FINAL DEVELOPMENT PLAN APPLICATION

PROPERTY INFORMATION			
Project/Property Address: Sheetz Gahanna / TBD (Lot Combination in Progress)		Project Name/Business Name: Sheetz Gahanna	
Parcel #: 025011244,025011243,025011226	Zoning: (see <i>Map</i>)	NC	Acreage: 4.19

RE: Project Sheetz Gahanna Final Development Plan

RE: Sheetz Gahanna | Plan Review

SITE PLAN

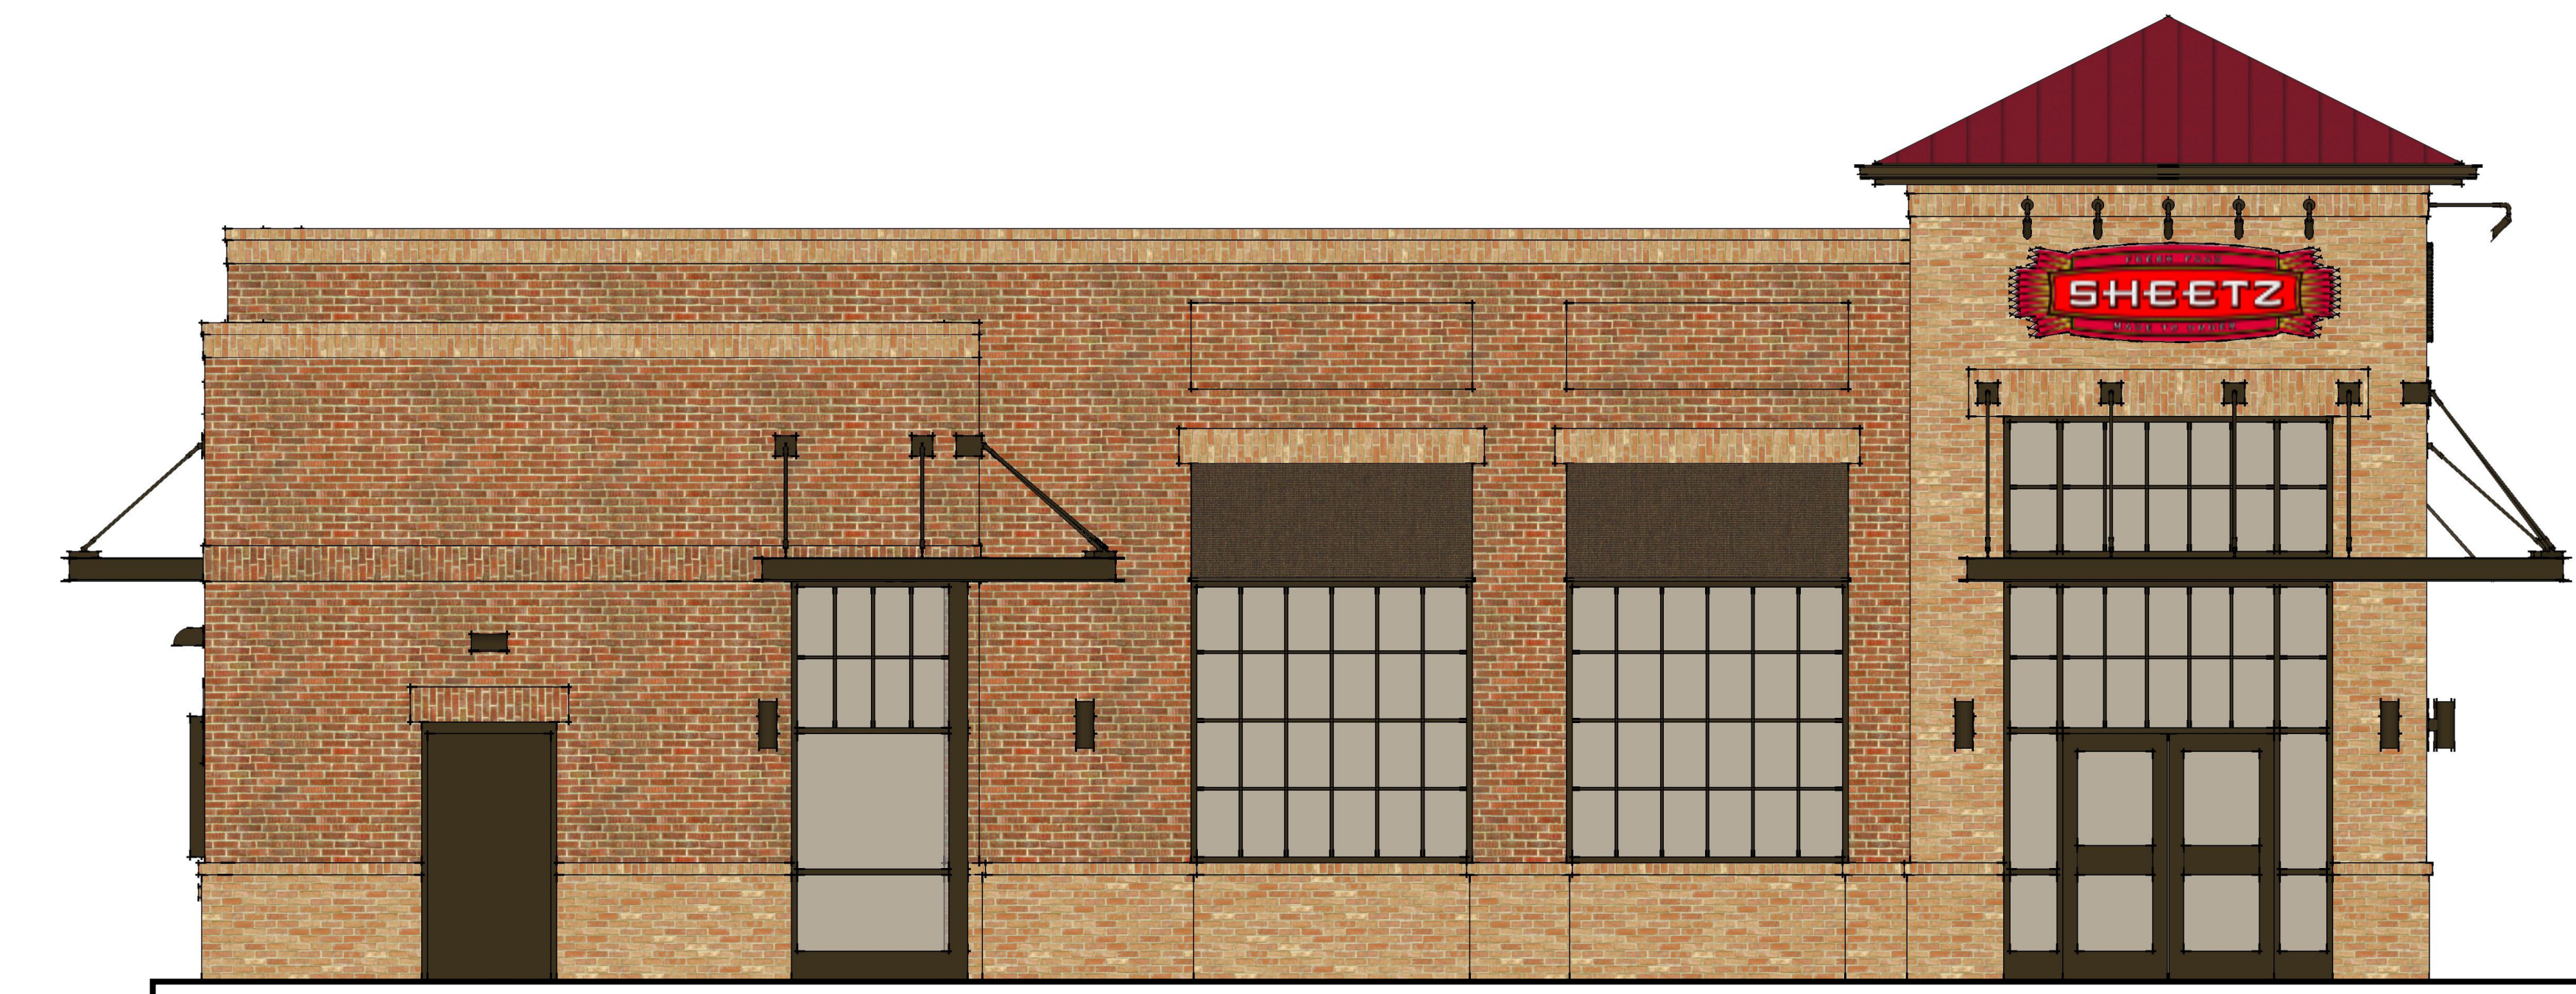
4. Minimum 15ft side yard building setback required per Section 1153.02(c)(4). Please revise the site plan.
5. It appears the portions of the proposed fences will be within the public right-of-way. Structures within the R/W are not allowed unless otherwise permitted by engineering. Please reach out to engineering division for more information. Label the height and type of the fence.
6. Label the height of the building.
7. Access drives shall not exceed 35 feet wide per Section 1163.03(a). 36 feet is proposed.
8. Section 1167.18(c)(1) requires trash receptacles to be located to the rear of the main structure. A variance may be requested.
9. A variance application is required for not providing the minimum amount of interior parking lot trees per Section 1163.08.

15. Access drives are to be a maximum of 36' wide per Gahanna Codified Ordinance 1163.03. Revise plans to show a 35' access drive.
16. Proposed fence is shown in public right-of-way on both frontages. Please shift locations to outside right-of-way.

The subject site is subject to the New Albany Company's design requirements, some of which differ from the City of Gahanna's. The proposed fence design and location is being driven by NACO's requirements and the intent is to match their standard specifications for 4' horse fencing. Coded note R has been added to the Site Plan with the fence details:

4. Minimum 15ft side yard building setback required per Section 1153.02(c)(4). Please revise the site plan.
 - [The setbacks have been adjusted to meet and address this comment.](#)

- [See cover letter for response by Skilken Gold.](#)
6. Label the height of the building.
 - [Addressed as stated on the site plan](#)
7. Access drives shall not exceed 35 feet wide per Section 1163.03(a). 36 feet is proposed.

- [Plans updated to show 35' wide access drive.](#)
8. Section 1167.18(c)(1) requires trash receptacles to be located to the rear of the main structure. A variance may be requested.

- Plans updated to show 35' wide access drive.
16. Proposed fence is shown in public right-of-way on both frontages. Please shift locations to outside right-of-way.

TREE PRESERVATION PLAN

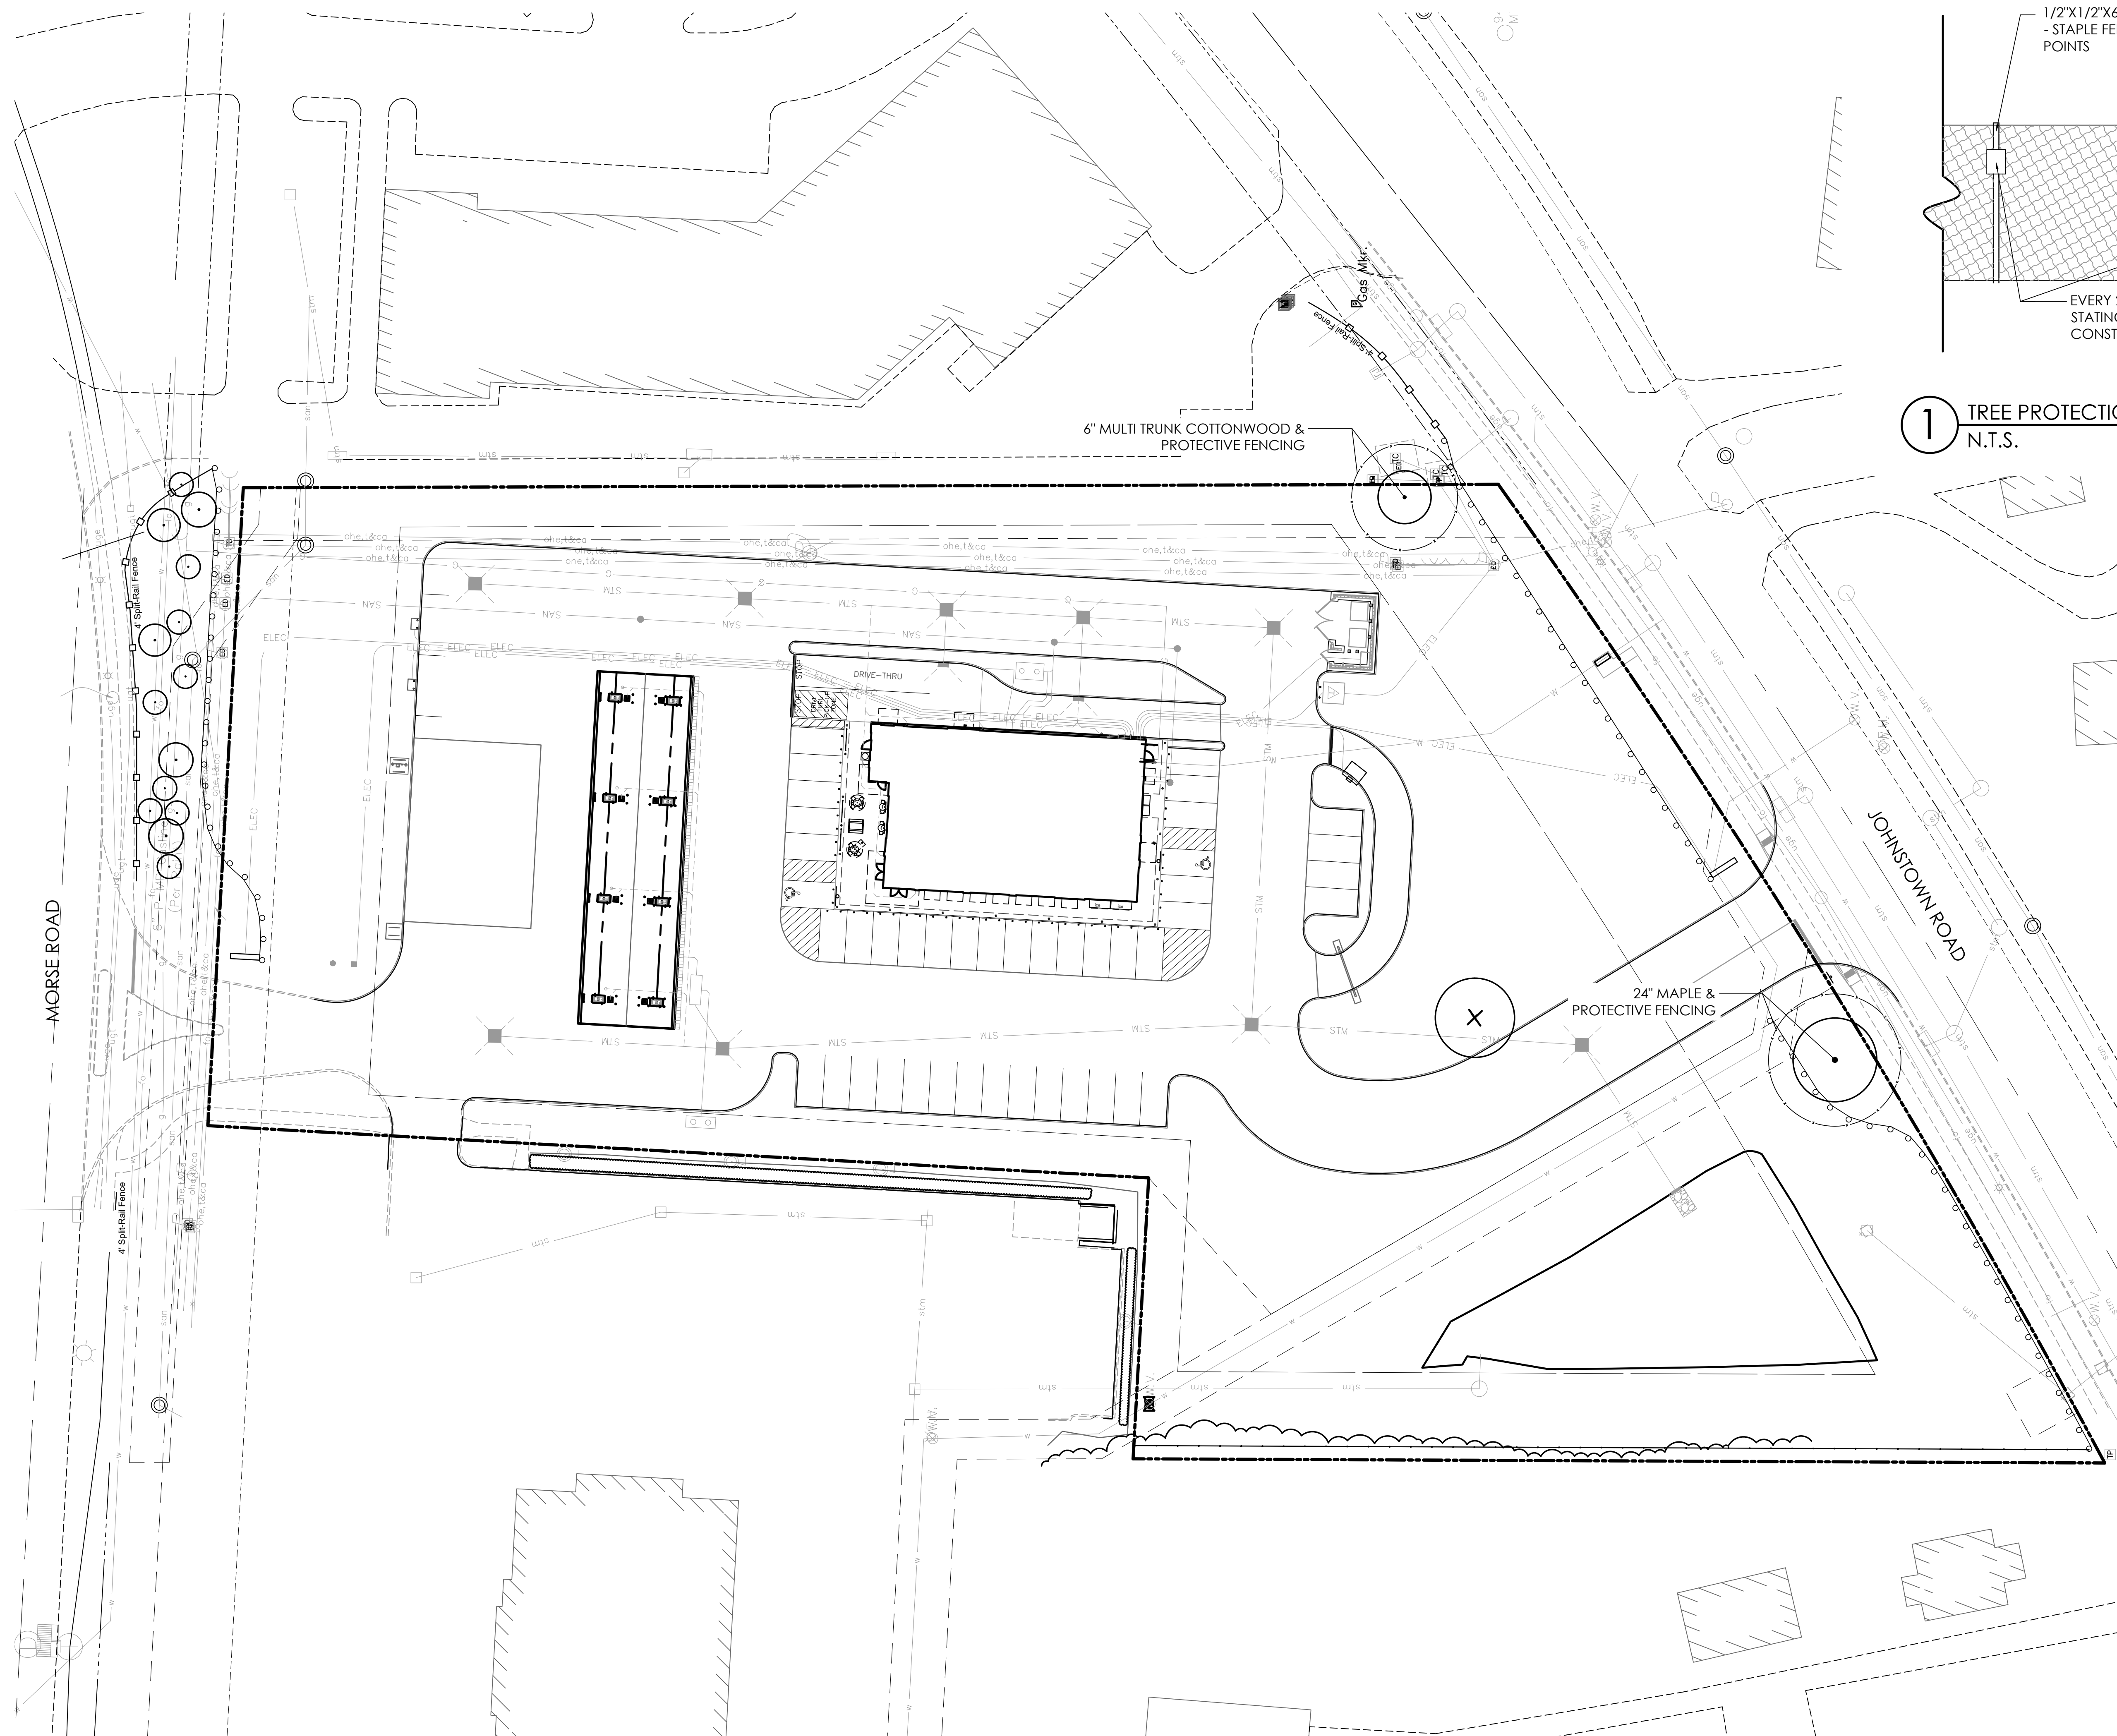
Comment #21 (Parks) with Response by Skilken Gold, in coordination with Landscape Architect 21. The species selection for new plantings looks appropriate, and I am glad to see specs for protective fencing included. I would like to see the species and condition of proposed preserved trees included in plans. Planting specifications look appropriate. I did not see a variance come through for the interior landscape requirements, but I see in the notes that a variance is to be requested for 26 trees.

Sheet L-3 has been updated to include general identification of the existing trees on-site that are to remain. The tree to remain in the middle of the E. Johnstown Road frontage is a maple (Landscape Architect thinks it is a sugar maple), and the tree in the SE corner of the site is an Eastern Cottonwood. The trees within the public right-of-way, along the Morse Road frontage are a mix of oak, maple and sycamore trees.
